Product change notification (PCN)

Title / short description	AXL F BK S3 – 2701686, firmware 1.41
Affected article category	SPS and I/O systems
Change category	Function, Marking
Change number	CDR230106-AXL F BK S3 FW1.41-0
Reason for PCN/PDN Revision

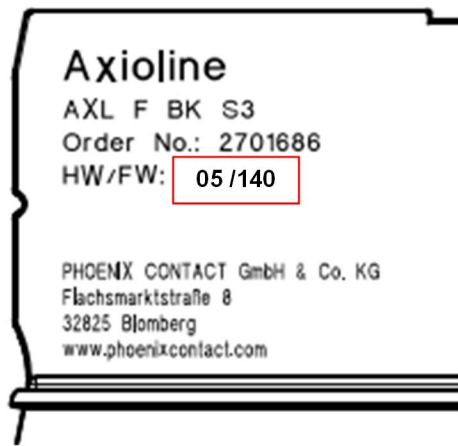
The following changes have been made for firmware 1.41:

- Removal of non-resettable error (connection loss): Sercos error code C30F4002
- The other technical properties, as described in the data sheets, remain unchanged

Item no.	Item Type	Hardware / Firmware		Item no.	Substitute item Type
		old	new		
2701686	AXL F BK S3	HW 05 / FW 1.40	HW 05 / FW 1.41
